Company	Trenz Electronic GmbH
PCN Number	PCN-20210612
Title	TE0782-02 eMMC Change
Subject	BOM change
Issue Date	2021-08-18

2.1 #1 Change eMMC (U5) from IS21ES08G-JCLI to SDINBDG4-8G-XI2

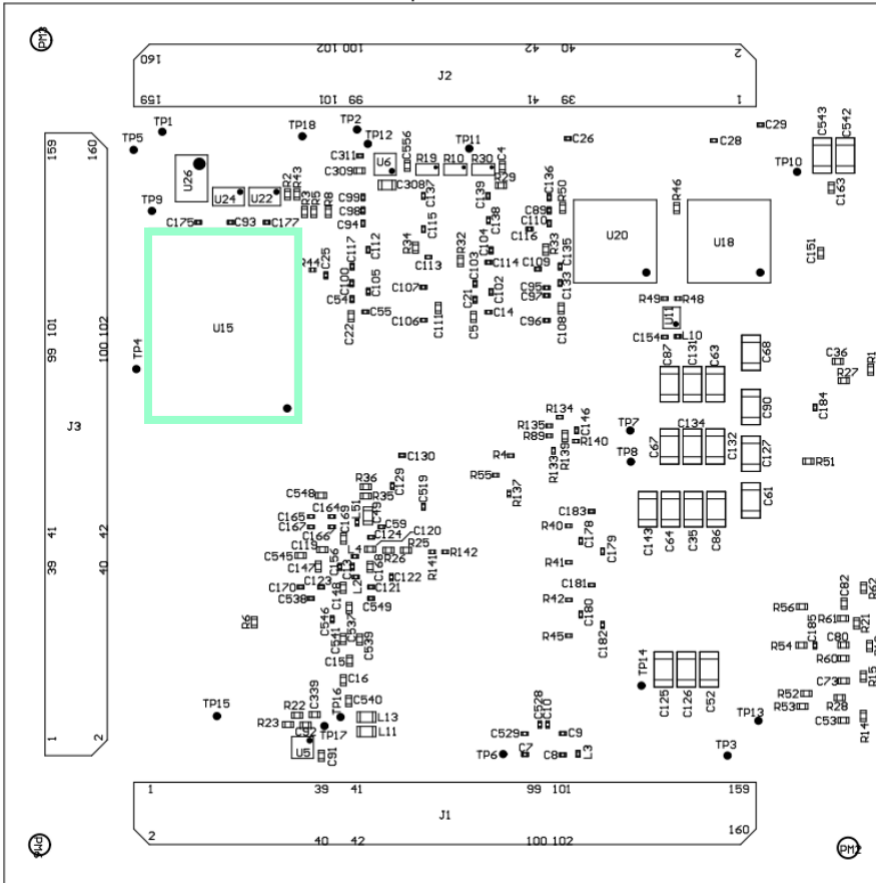
Type: BOM change

Reason: Distributor informed about unforeseeable immediate EOL of parts. No official documents from manufacturer are available. No LTB, already confirmed orders were canceled by distributor/manufacturer.

Impact: None. Replacement has same capacity as used on corresponding affected variant. Reference designs for vivado versions 2019.2 and 2020.2 were tested and work properly without any changes.

Locate eMMC (U15) on PCB:

From end of August 2021, after old stock is gone, all variants above are replaced by the corresponding variants.
